Vietnam Veterans Memorial Center

NCPG Revised Concept Submission April 3, 2009 | POLSHEK PARTNERSHIP ARCHITECTS

I. National Capital Planning Commission ACTION & COMMENTS

NCPC File No. 6597

REVISED DETAIL SECTIONS

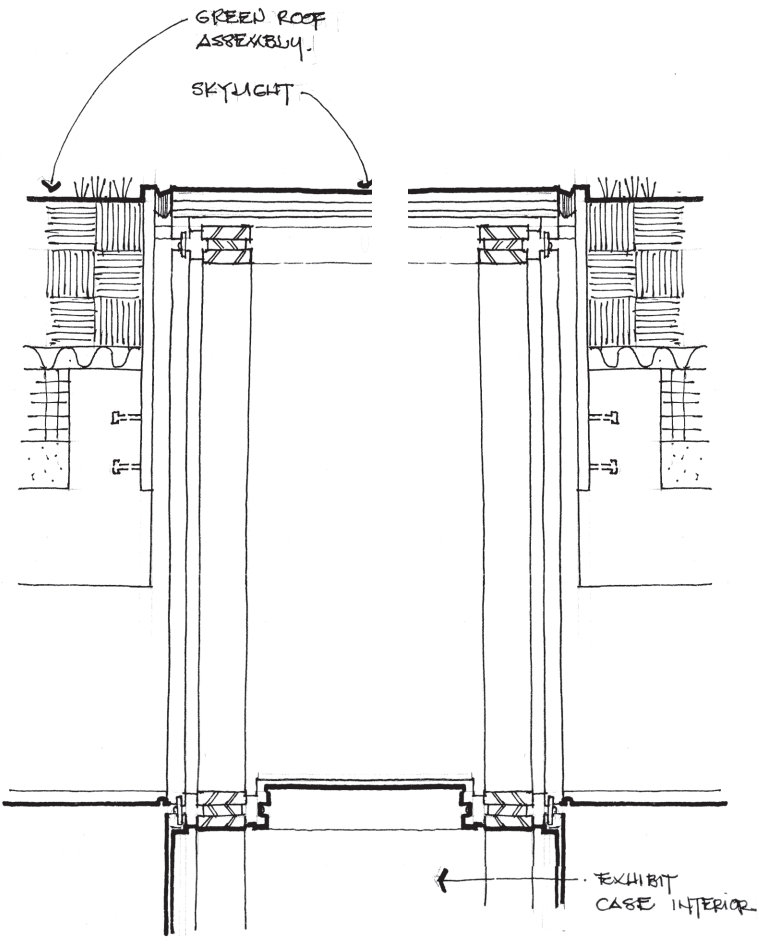
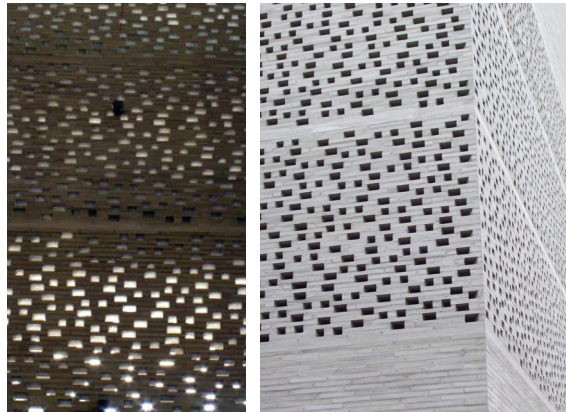
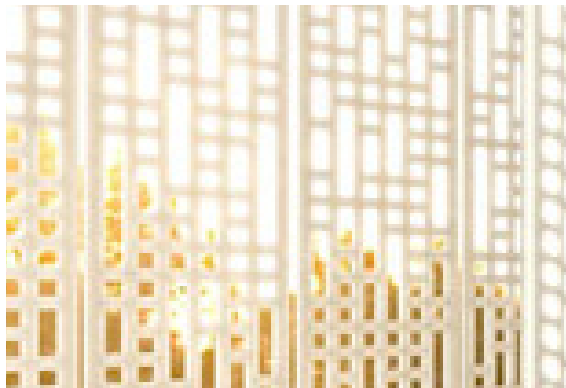
1. The exhibit wall skylights have been pulled down in section so that they are flush with the adjacent grade instead of protruding above the adjacent grass level. Consequently, there are no longer protruding volumetric skylight elements.

Finally, a refinement of the “ha-ha” detail which reduces the 18” high step at the bottom of the slope to a mere 6” curb improves the safety of this condition.

SCREEN FACADE SECTION DETAIL

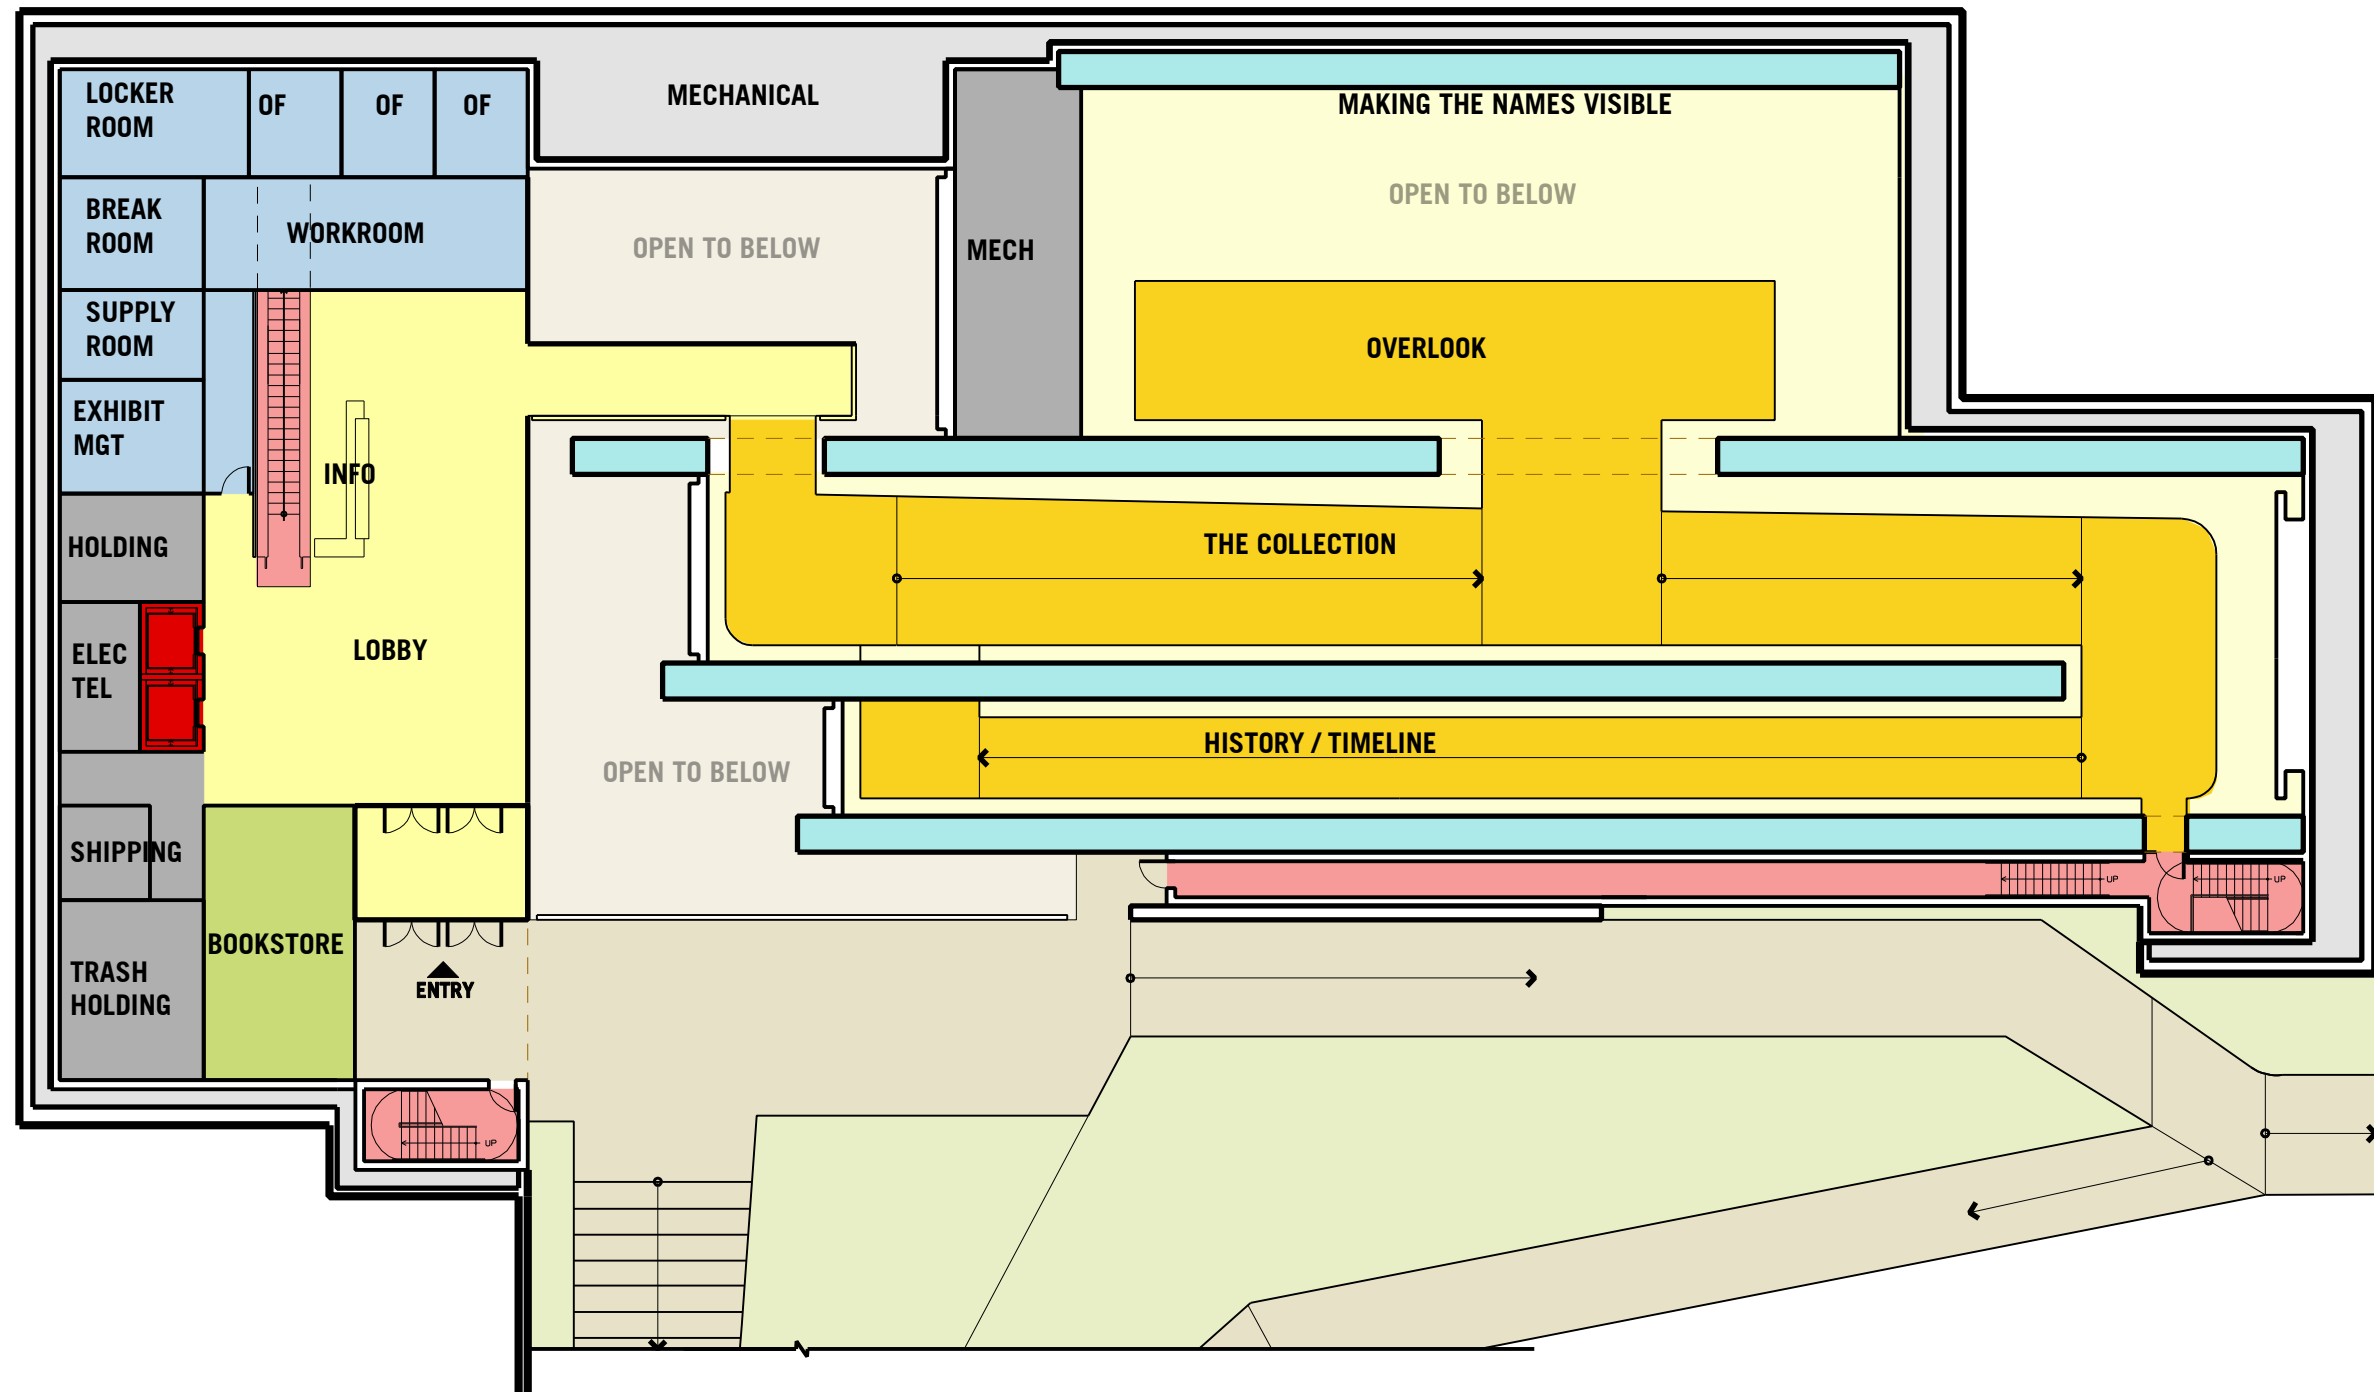
3. The guardrail condition along the northern perimeter of the courtyard is no longer achieved through the use of the exhibit walls, but is now created through the use of a lightweight architectural screen. This screen also acts as a sun control “veil” over portions of the building façade, allowing diffuse light to illuminate the interior while mitigating the effects of the direct sun. The screen further acts as a gentle separator between the emotionally charged experience of the interior and the activity of the outside world.

FOOTPRINT COMPARISON - UPPER LEVEL: 2007 VS. REVISED

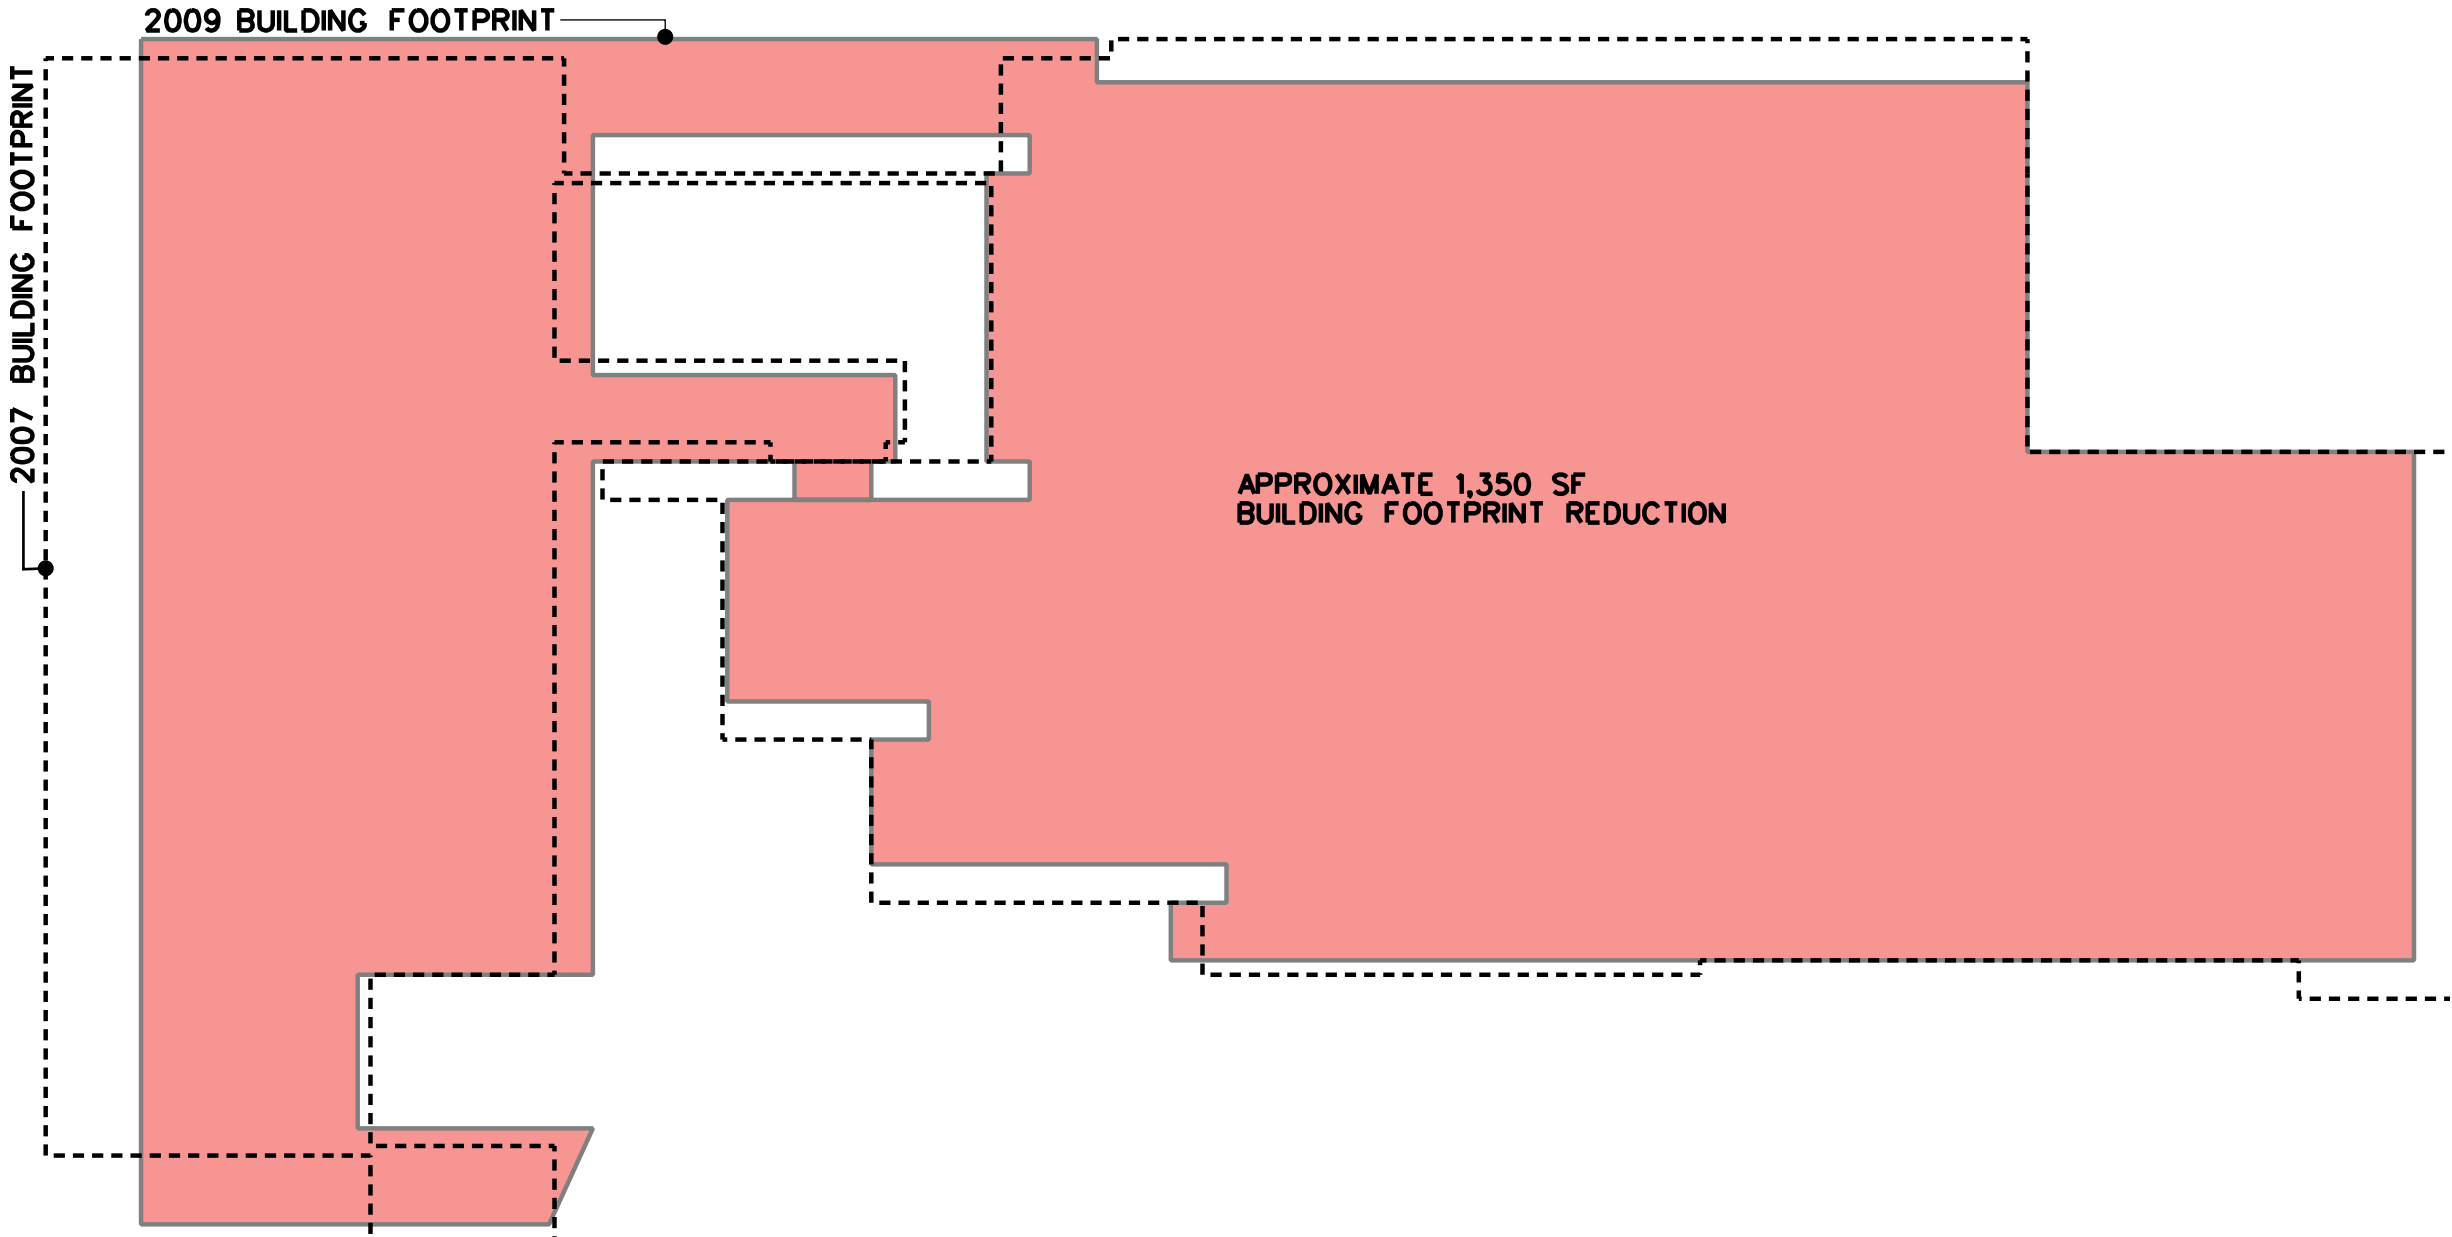
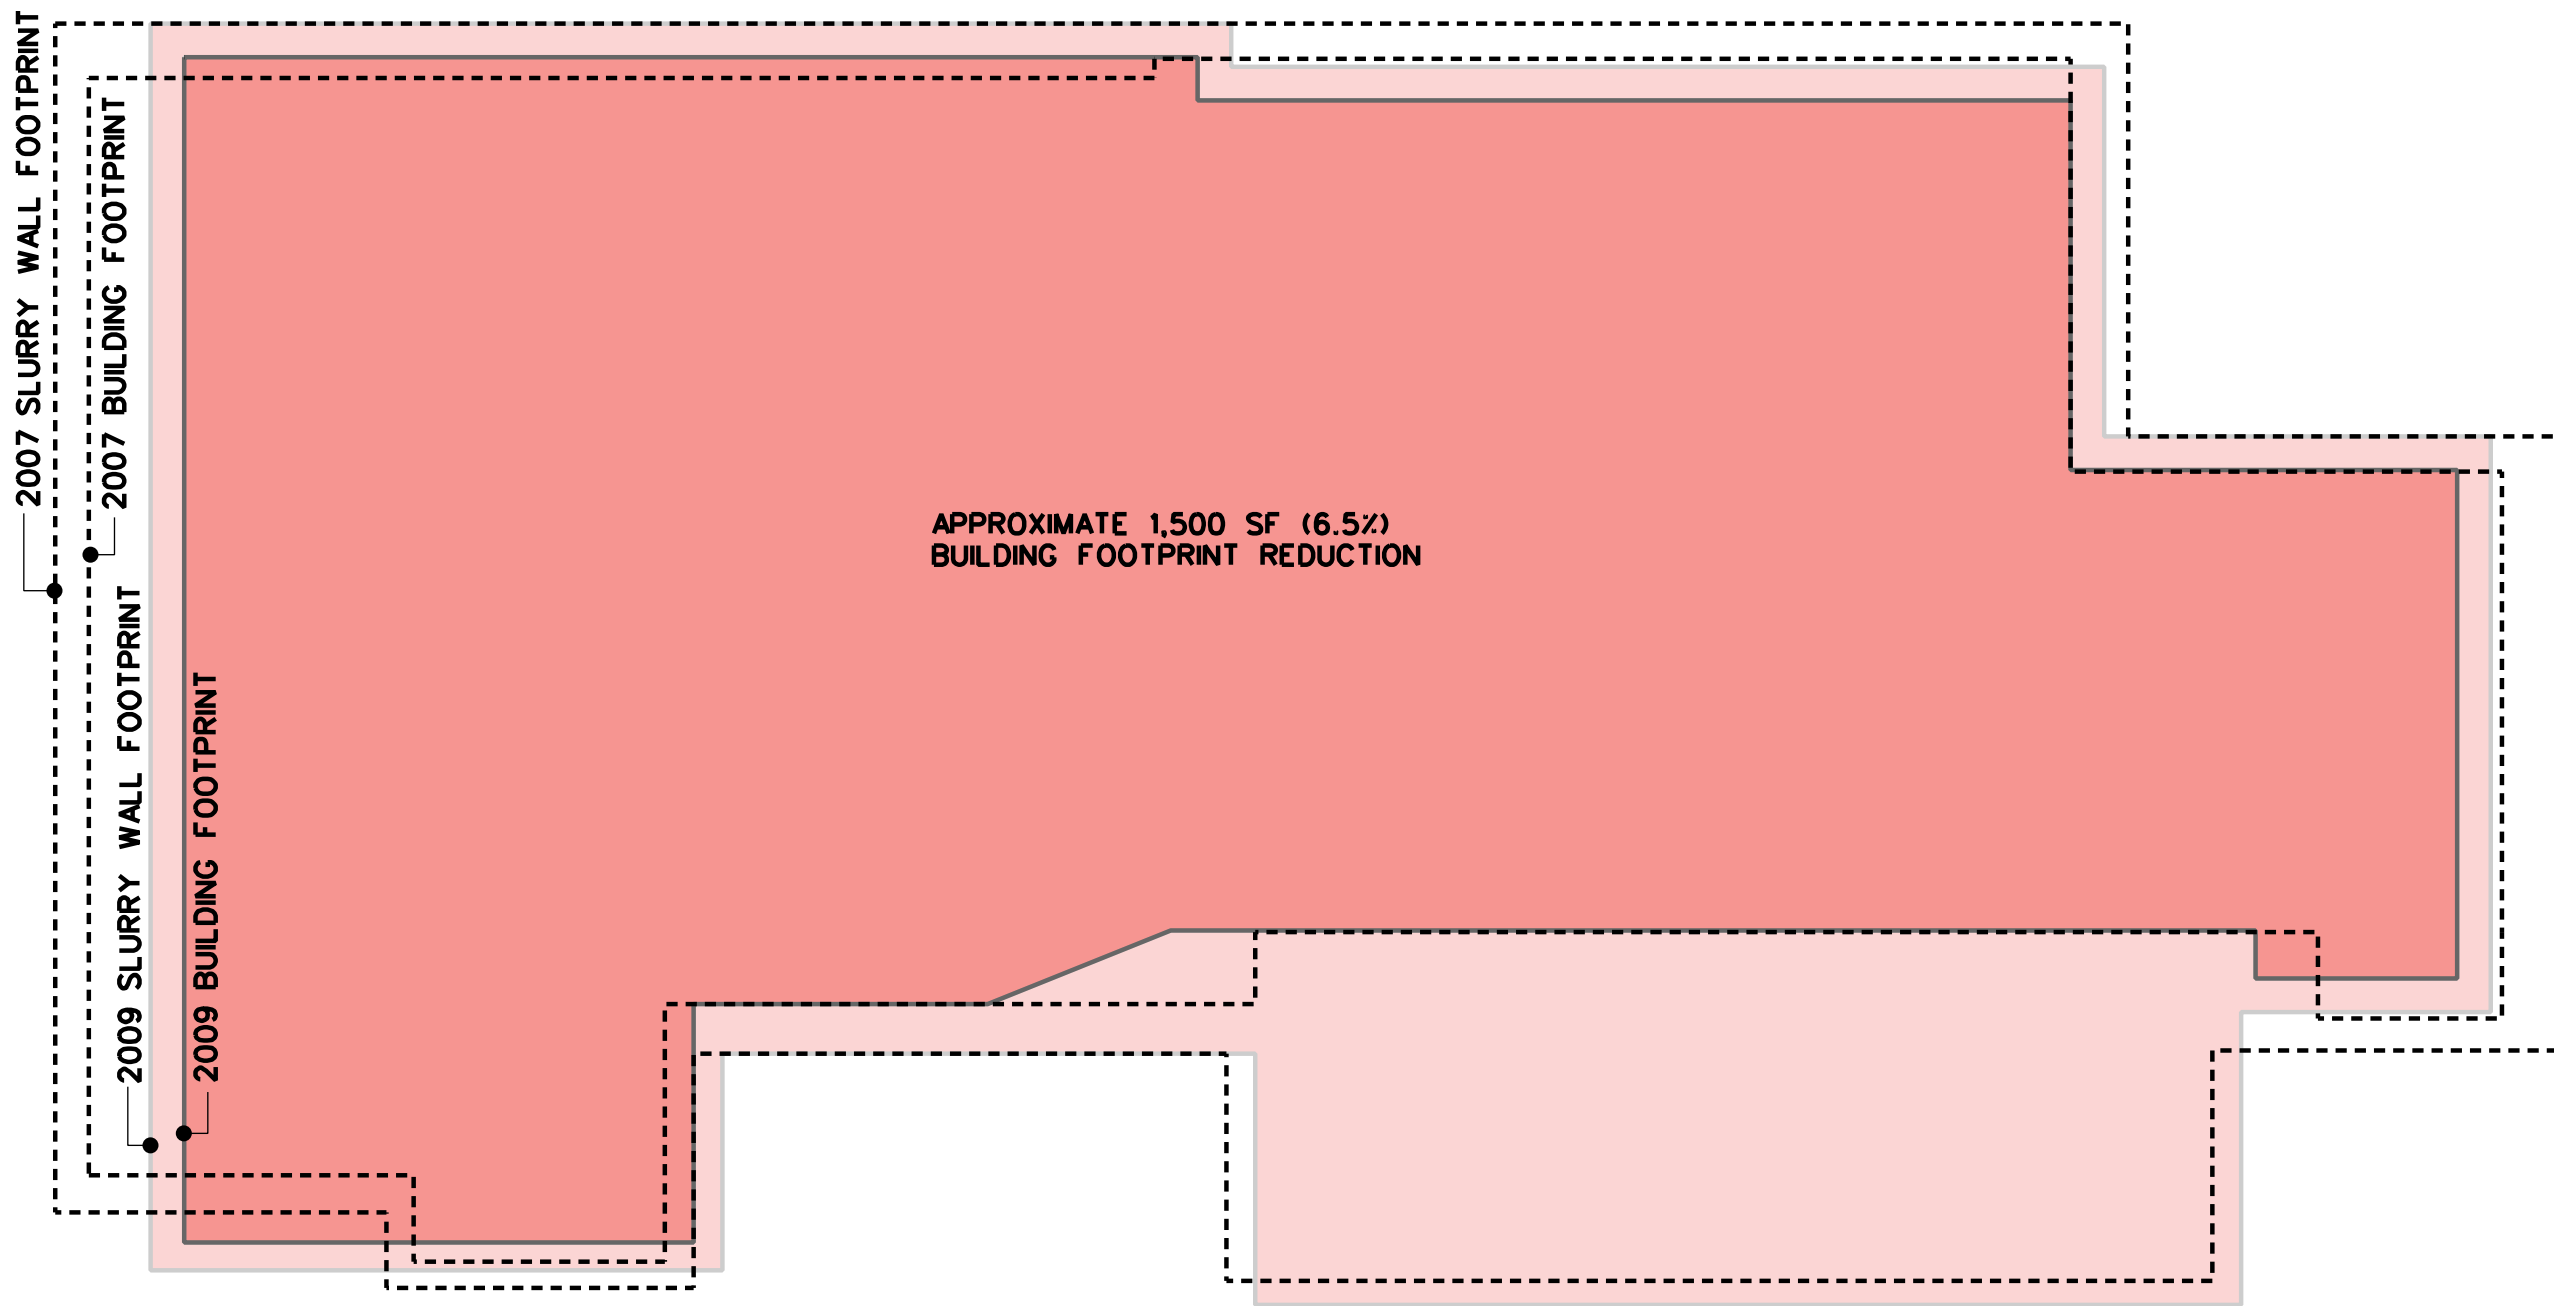
C. Building Planning and Size – Both the overall size of the building footprint as well as the overall gross area of the building have been reduced. This has occurred through a program reduction – the elimination of the Resource Center and Classrooms – as well as a modest reduction in the overall dimension of the courtyard.
